# Peak Apparels Ltd.

15<sup>th</sup> March 2021

# Buildings Information

# Observations

Table 8.1: Alternate Load Factors and Load Combinations

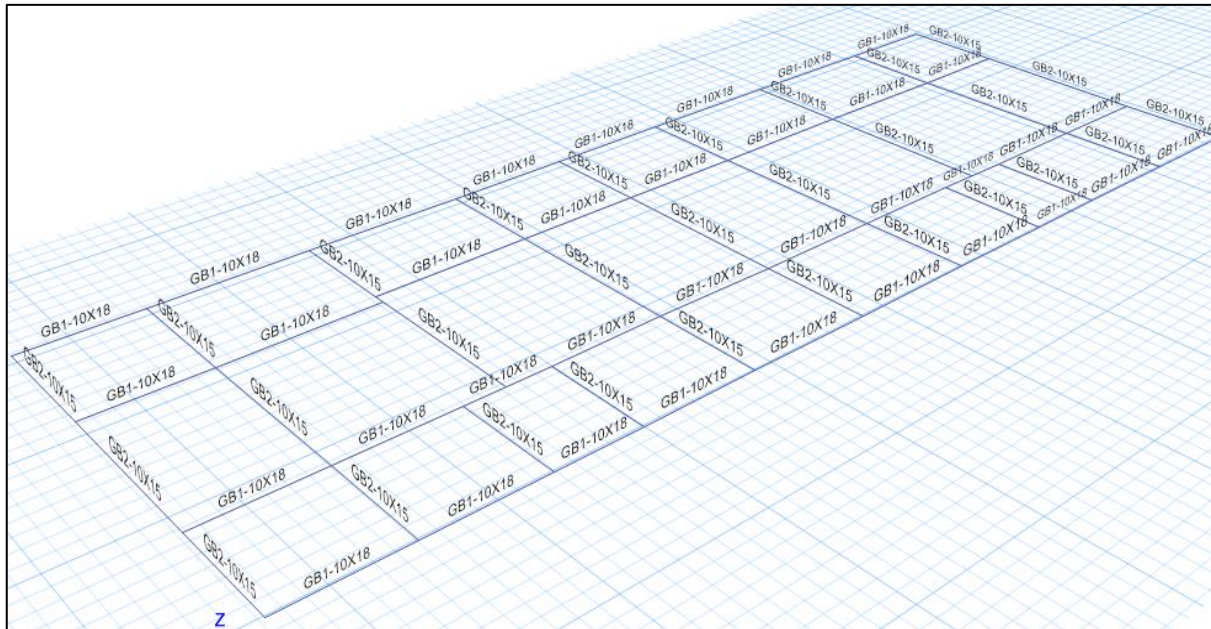
Load combination in DEA Report

In prepared Detail Engineering Assessment (DEA) of the building, NTPA load combinations were considered for retrofitting. Grade beam is assigned in FEA which is also present in structural drawing. However no adequacy check for grade beam has been provided in Detail Engineering Assessment (DEA) report.

Factory engineer is required to provide the justification for considering NTPA load combination to prepare the retrofitting design.

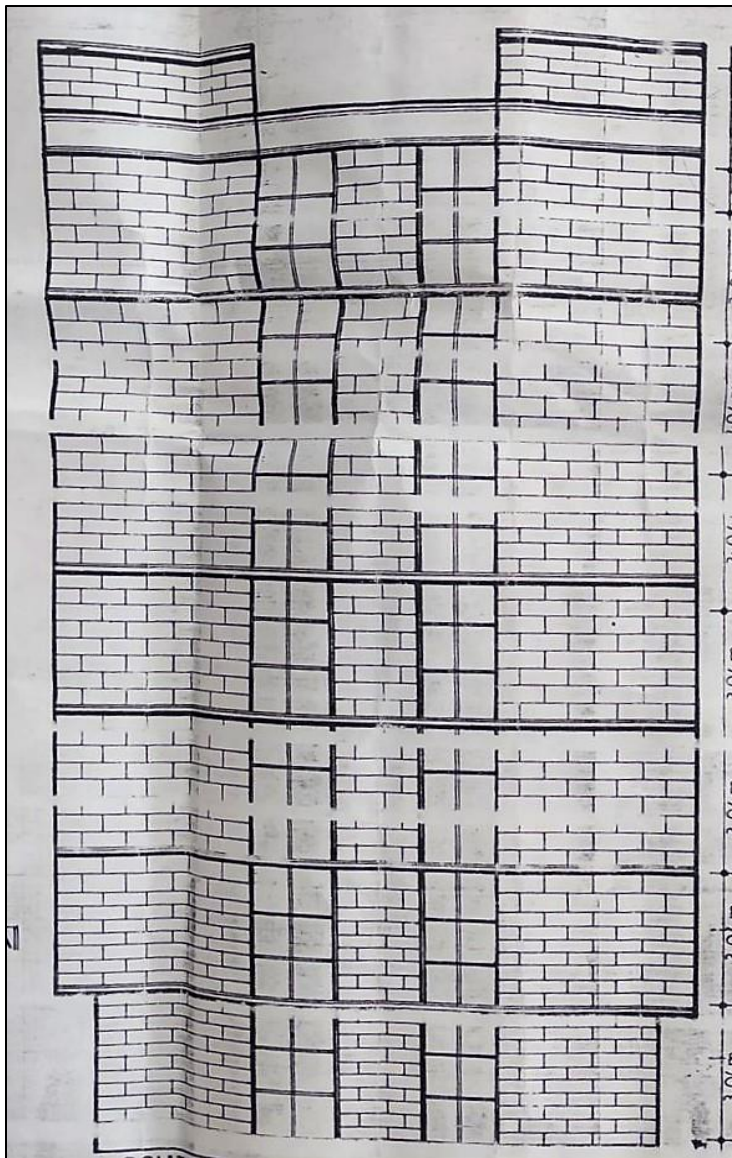
**Dampness found on slab and wall at several locations**

Dampness was found on the wall of toilet zone.

Dampness was found on roof slab soffit at several locations.

Dampness was found on slab at several locations.

Permit layout from LGED for 7 storied building

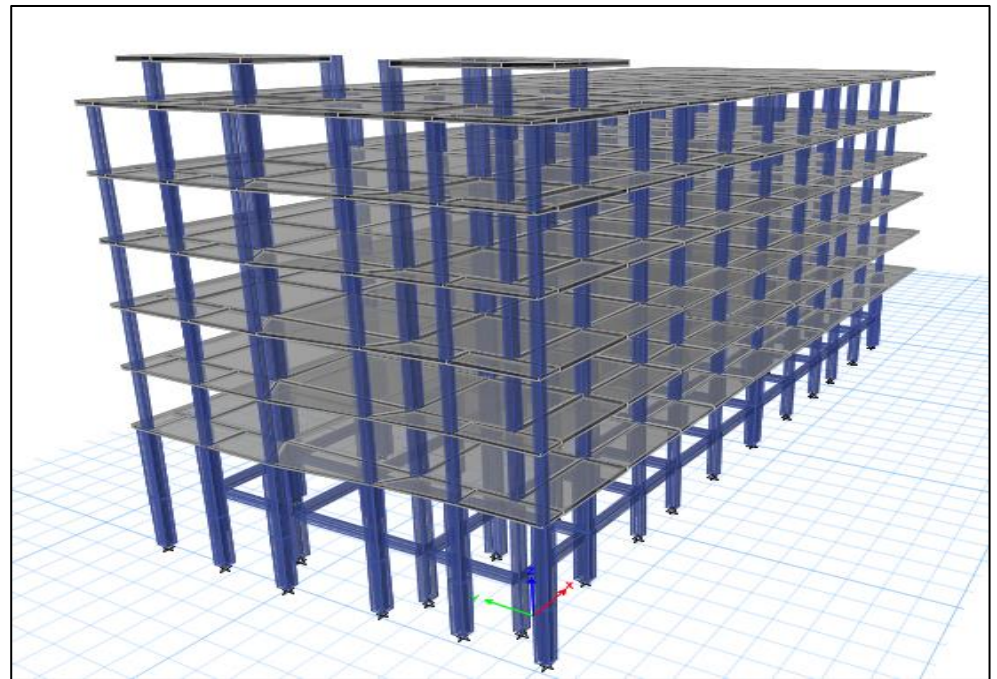
Design report prepared considering 6 storied

The building permit layout is for seven storied structure. The building can be extended vertically in future. But the DEA of the structure was done for six storied structure and till the date of this inspection, building was constructed up-to six stories. Prior to vertical extension above six stories, factory engineer is required to produce Detailed Engineering Assessment (DEA) for the further vertical extension of the structure according to BNBC and submit to RSC for review.
